Project
69-71 CHURCH ROAD
ANERLEY
CRYSTAL PALACE

Title
PROPOSED PLANS
LOWER GROUND AND GROUND FLOOR
SHOWING COMPARISON WITH
APPROVED SCHEME

Drawing No. **7451-PD-210** Revision

LOWER GROUND FLOOR PLAN - COMPARISON
SCALE 1:100

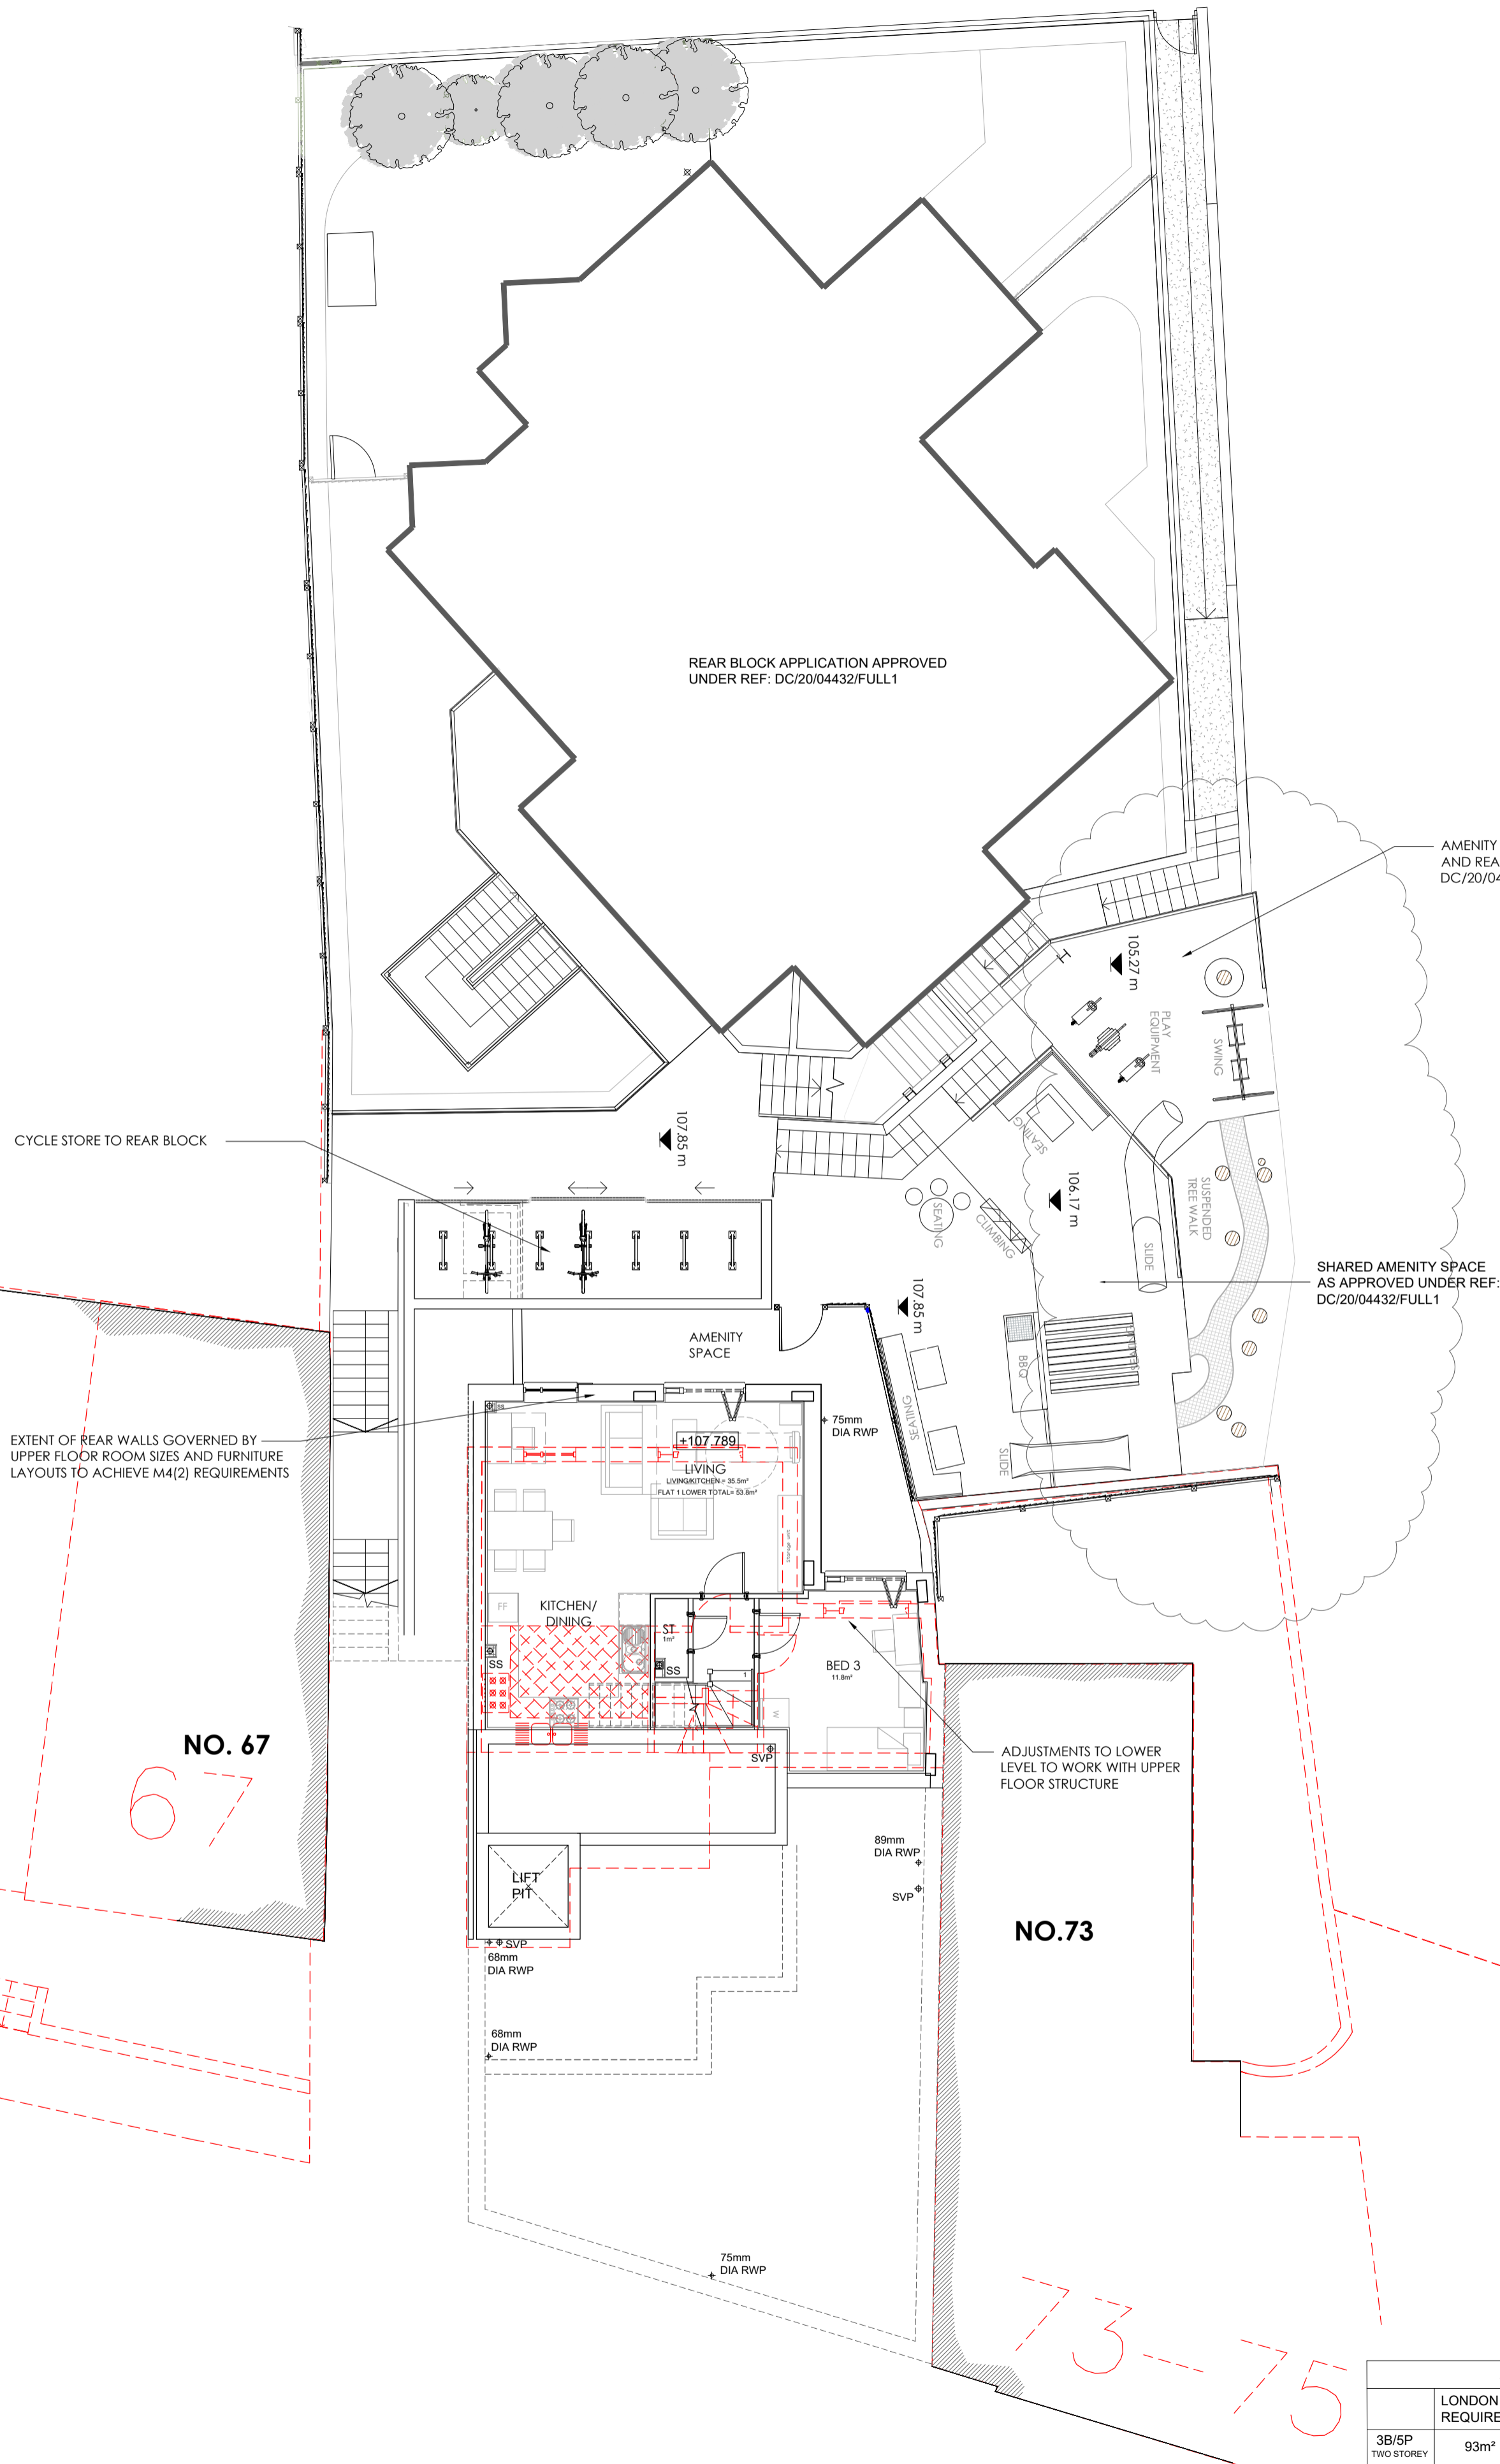
DIFFERENCES FROM APPROVED DRAWINGS:

- OVERALL HEIGHT REMAINS AS APPROVED. PARAPET AT TERRACE LEVEL RAISED APPROX 150MM TO ALLOW FOR INSULATION TO ROOF AND WATERPROOFING UPSTAND.
- REAR OF BUILDING EXTENDED TO ALLOW FOR NECESSARY INTERNAL LAYOUT CHANGES TO ENABLE COMPLIANCE WITH BUILDING REGULATIONS - SPACE STANDARDS AND AD M4(2) (CONDITIONAL REQUIREMENT FOR PREVIOUSLY APPROVED SCHEME).

- FLOOR AND WALL THICKNESSES INCREASED WHERE REQUIRED TO ACHIEVE REQUIRED THERMAL AND SOUND INSULATION PROPERTIES TO COMPLY WITH BUILDING REGULATIONS.
- ANGLE OF FRONT WALL OF RESIDENTIAL UNITS REVISED TO GAIN REQUIRED SPACE TO COMPLY WITH FLAT / ROOM SIZES.

- DOORS TO SIDE ELEVATION ALTERED TO SIMPLIFY CYCLE/BIN STORE ACCESS AND TO ADD EXTERNAL ENTRANCE DOOR TO FLAT 1 TO COMPLY WITH BUILDING CONTROL FIRE STRATEGY.

- WINDOWS RELATIVELY UNCHANGED BUT POSITIONS REVISED SLIGHTLY TO SUIT INTERNAL LAYOUTS AND NECESSARY STRUCTURAL ELEMENTS.
- WINDOWS ADDED TO RECESSED ELEVATION AT REAR TO COORDINATE WITH PLANS. APPROVED PLANS HAD WINDOWS SHOWN ON PLANS BUT NOT ON ELEVATION.

- THE LIFT, AS APPROVED, WAS TOO SMALL TO COMPLY WITH AD M4(2) REQUIREMENTS. NEW LIFT INCREASED TO ACHIEVE REQUIRED CAR SIZE.
- LIFT OVER-RUN ADDED TO ELEVATION. NOT INDICATED ON APPROVED ELEVATIONS.

- SOME ELEMENTS OF RENDER REPLACED WITH BRICKWORK.
- STEEL FEATURE BEAMS ADDED TO REAR TO LINK DESIGN WITH APPROVED BUILDING AT REAR.
- PRIVACY SCREEN TO ROOF TERRACE RAISED AND FORMED WITH FROSTED GLASS.

- LOWER GROUND FLOOR AND GROUND FLOOR LEVELS LOWERED TO ENABLE PRIMARY ACCESS FROM SIDE PATH. ALSO ALLOWS ACCESS FROM REAR AMENITY SPACE OF FLAT 1 TO LARGER SHARED AMENITY AREA. WINDOW LEVELS ADJUSTED TO SUIT.

- LEVEL ACCESS ROUTE WITH GUARD RAIL TO FRONT BLOCK'S REFUSE / CYCLE STORE.
- TO COMPLY WITH FIRE STRATEGY AND BUILDING REGULATIONS THE CYCLE STORE WAS NOT ABLE TO BE ACCESSED FROM STAIRCORE SO HAS BEEN COMBINED WITH REFUSE STORE WITH EXTERNAL ACCESS.

- 1 STAIRCASE ADJUSTED TO COMPLY WITH BUILDING REGULATIONS
- 2 LIFT SHAFT ENLARGED TO SMALLEST DISABLED COMPLIANT LIFT. LIFT ON APPROVED DRAWINGS TOO SMALL.
